Docket Number:	26-OPT-02
Project Title:	Seahawk Battery Energy Storage System
TN #:	271173
Document Title:	Stop Lithium BESS Comment Letter
Description:	N/A
Filer:	Alene Taber
Organization:	Alene Taber Law, APC
Submitter Role:	Public
Submission Date:	7/2/2026 11:26:41 AM
Docketed Date:	7/2/2026

RE: Seahawk Battery Energy Storage System; Docket 26-OPT-02; County Code/Measure J/Agricultural Impacts Comments

Exhibit 10
+
Example #1

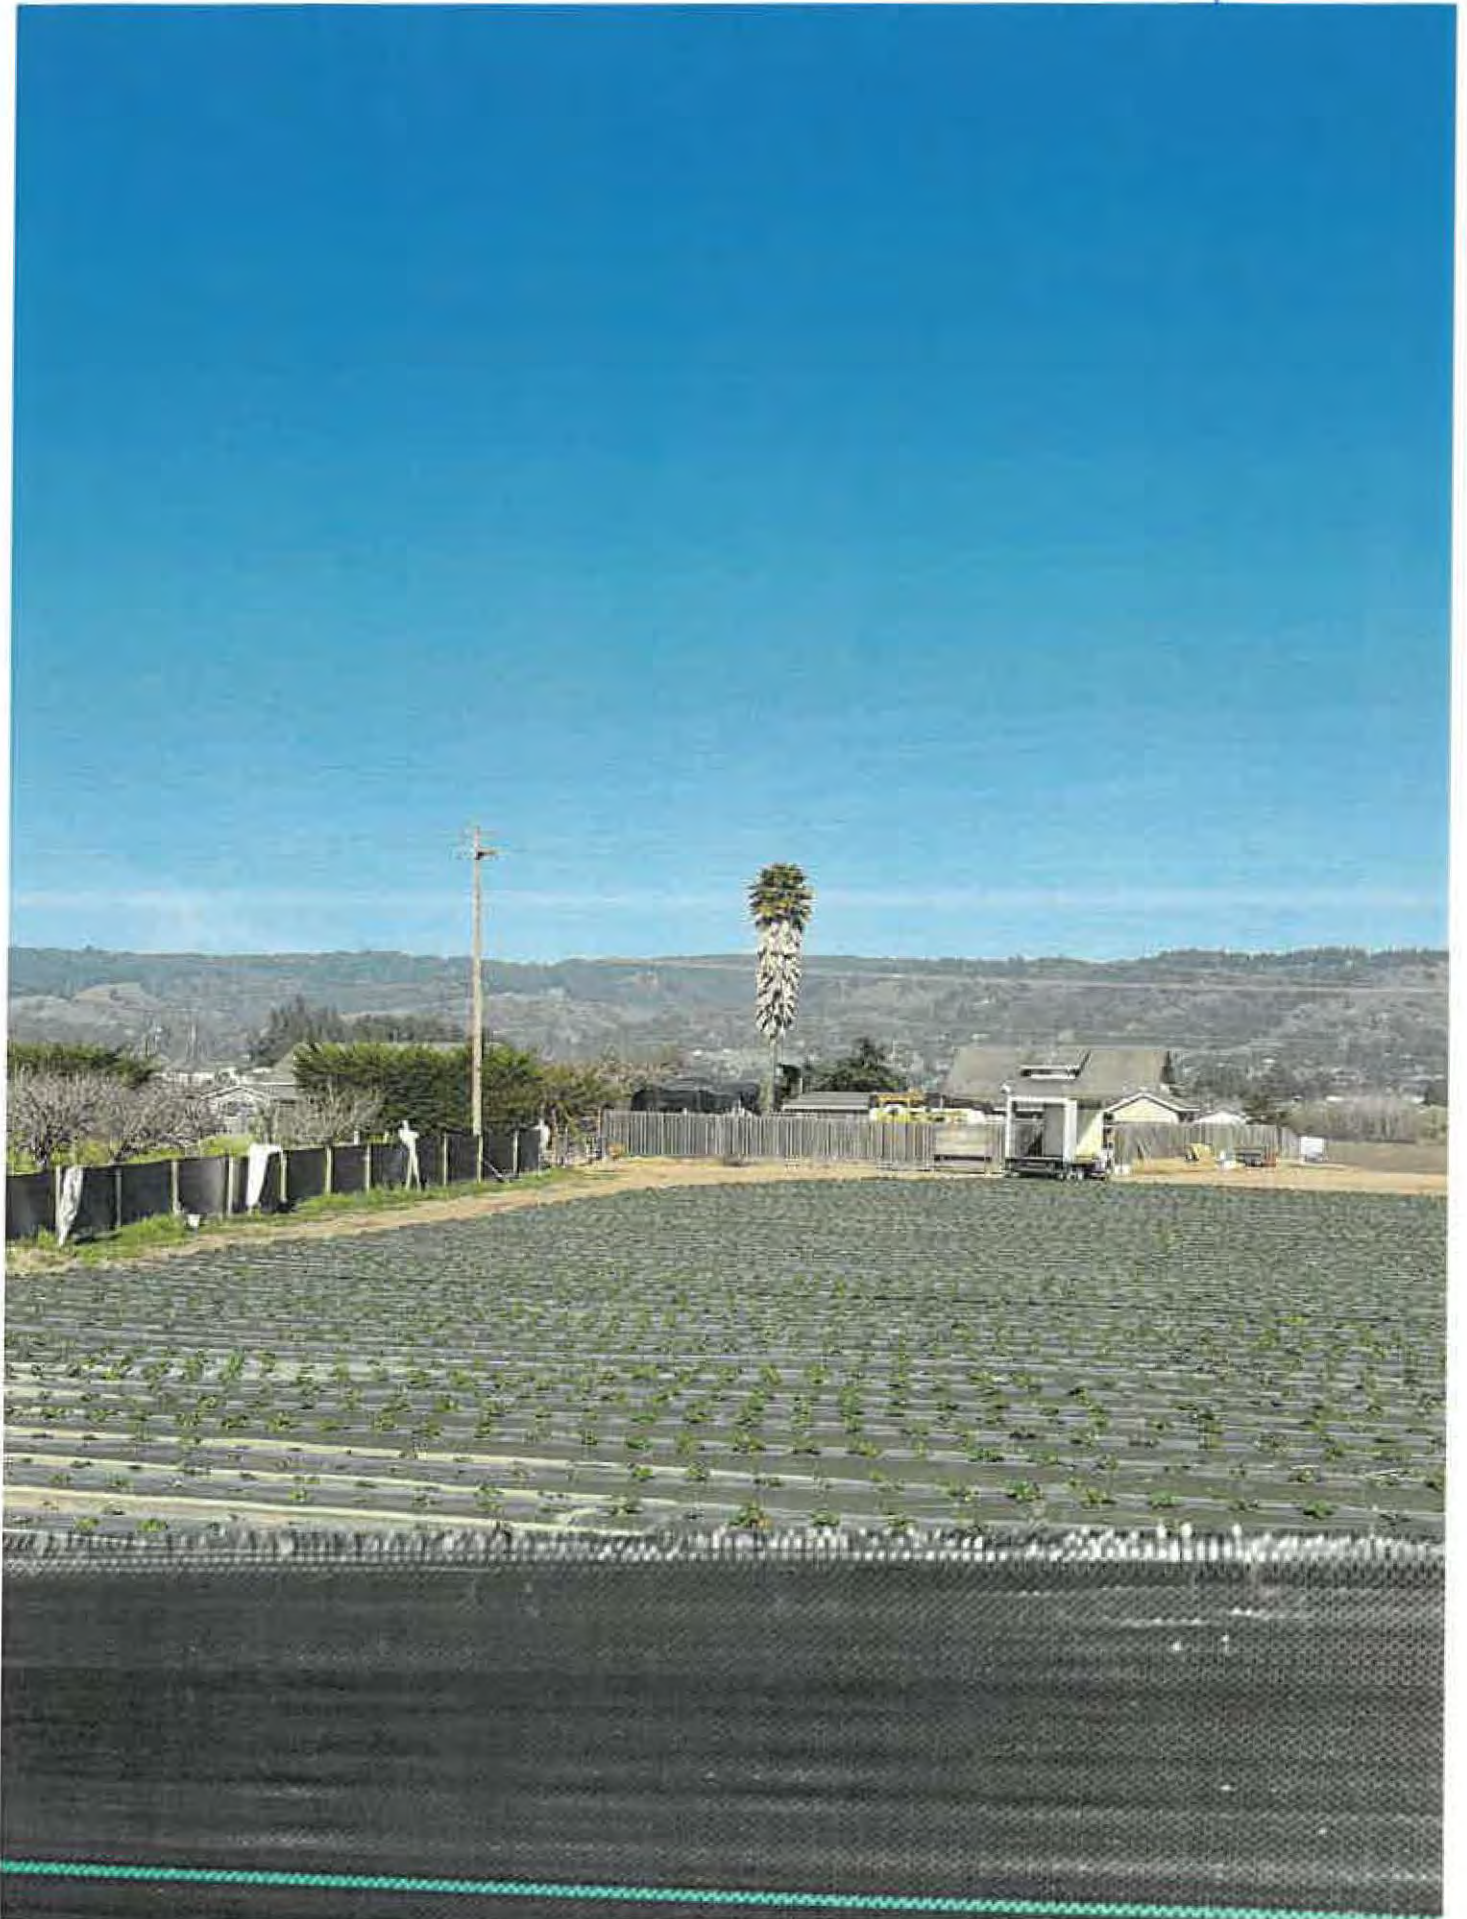
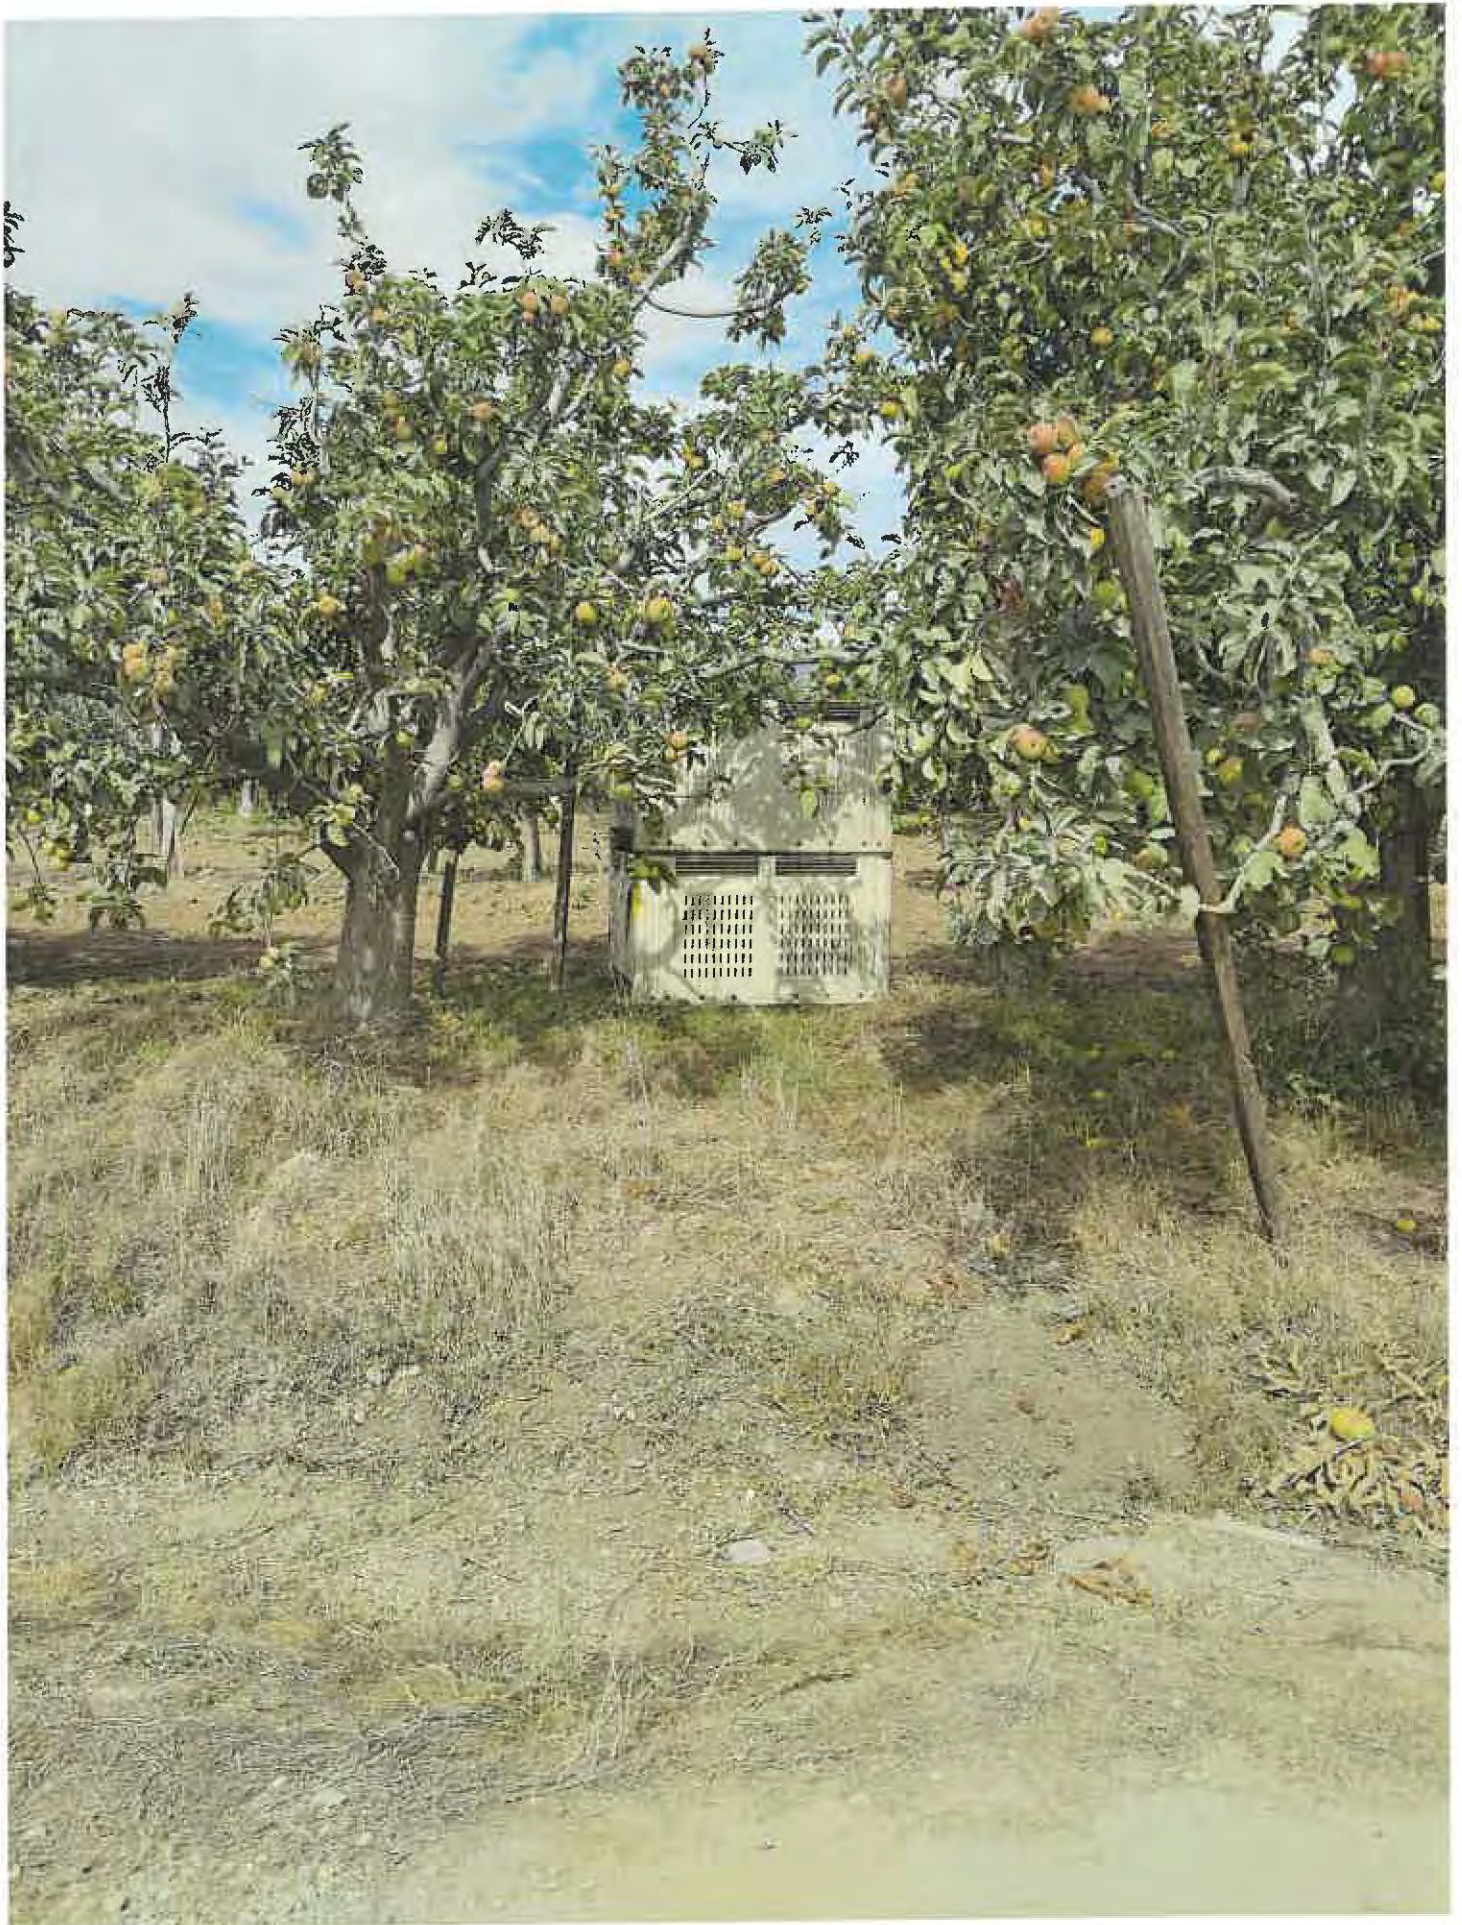
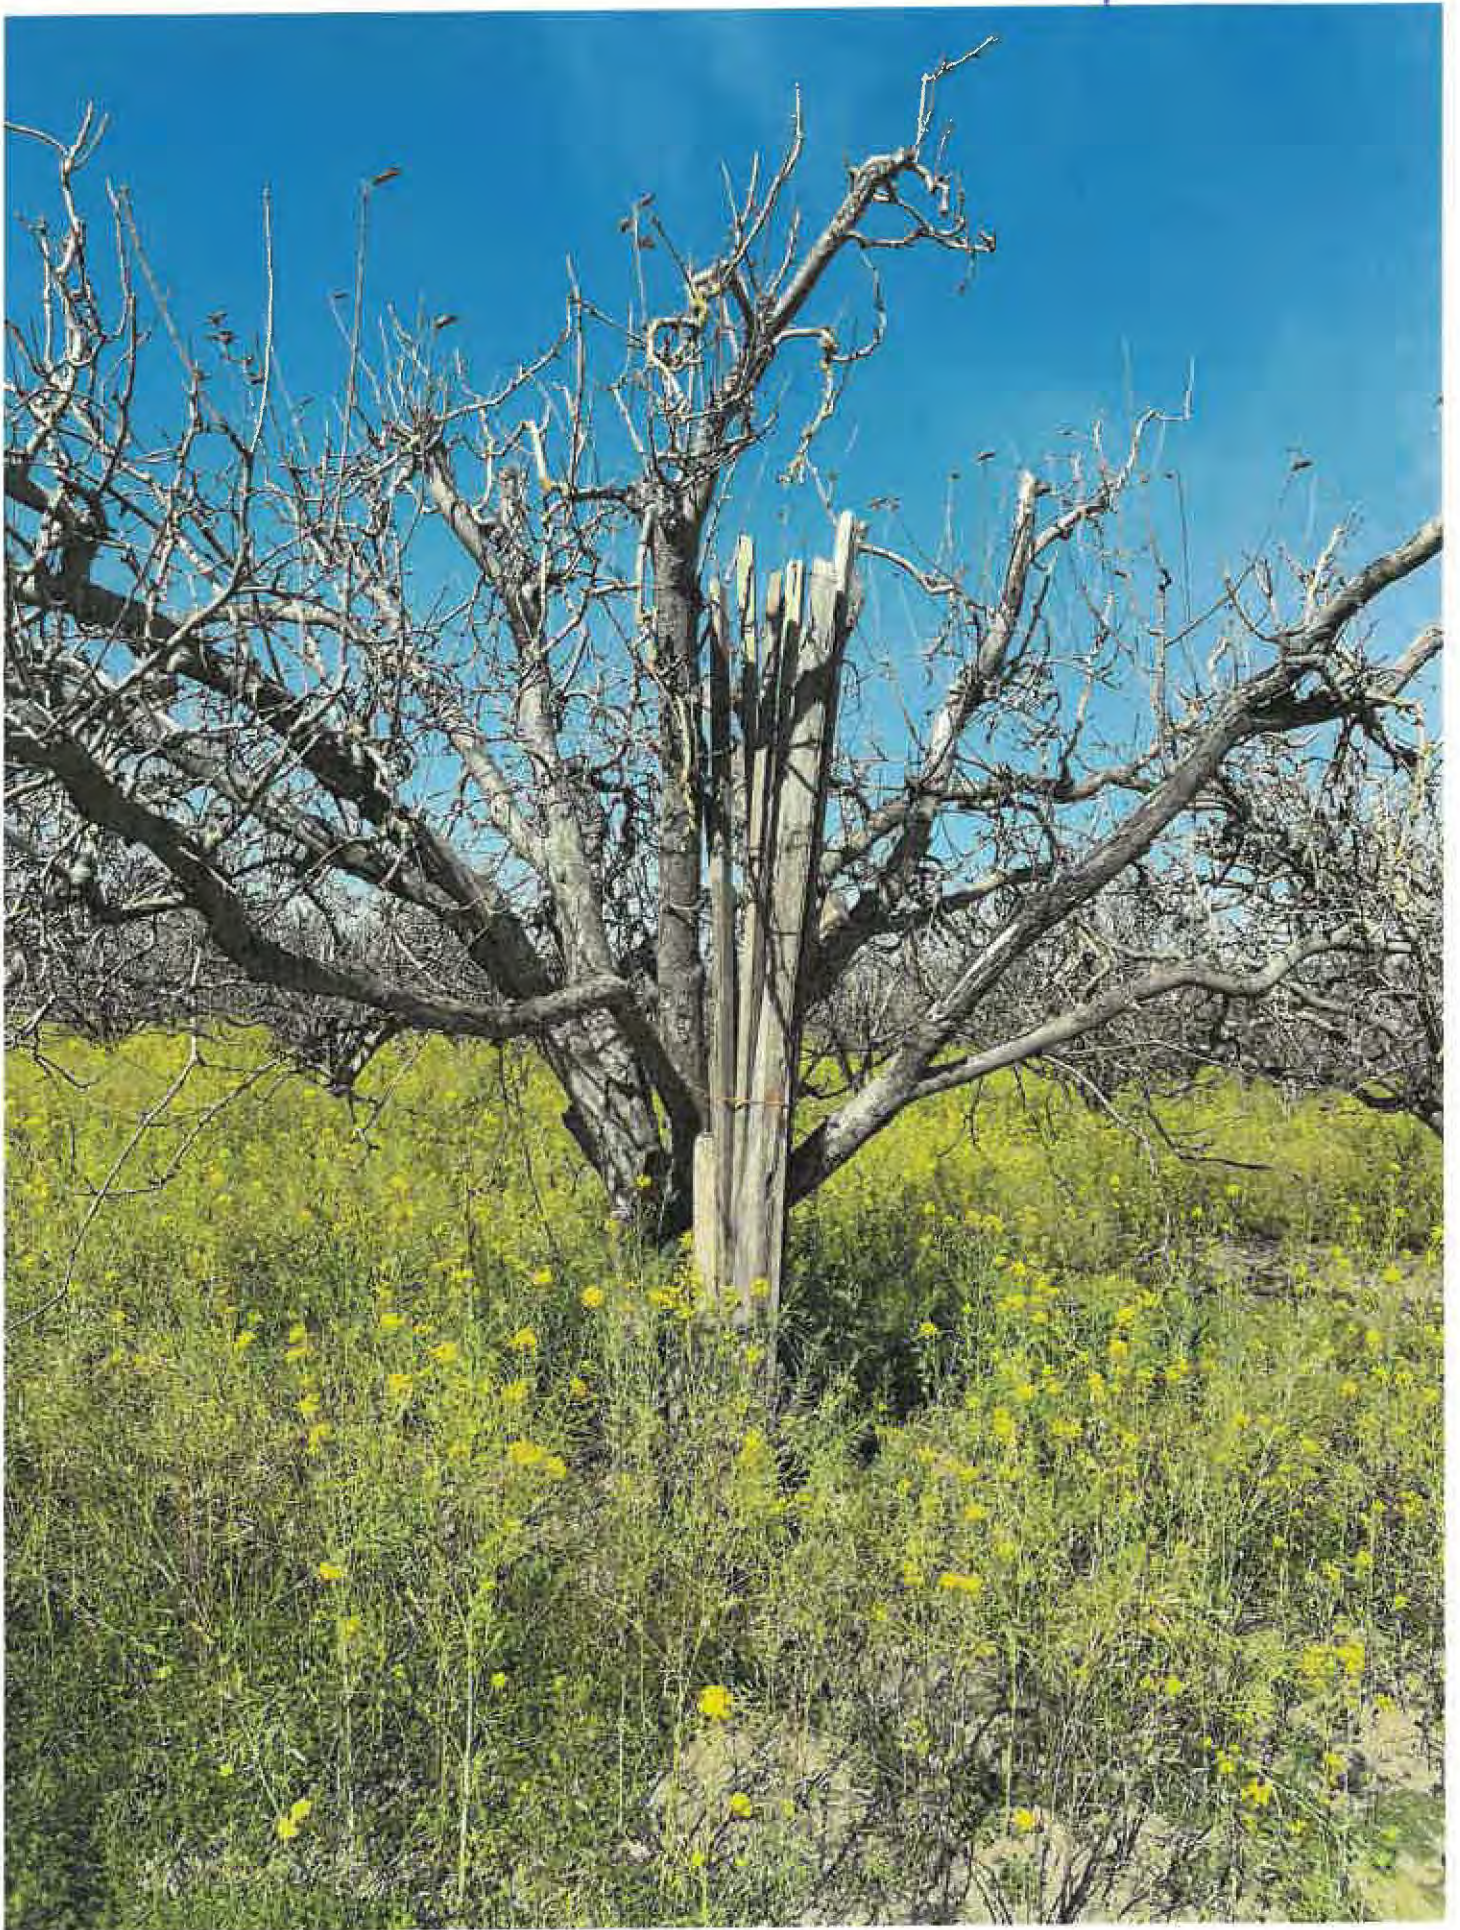
The developer's Ag. Viability Analysis Report claims (supported with their photos as Exhibit 13 on page 25) the soils in the area where the BESS Project is proposed to be located is very poor-quality "hydric" soil, citing only a soil unit map, but without any on-site soil sampling to verify actual soil quality. The "Soil Survey" (page 3 of the Report) cites the USDA Soil Map (Exhibit 16) indicating a Watsonville Loam (Soil Map Unit 177)
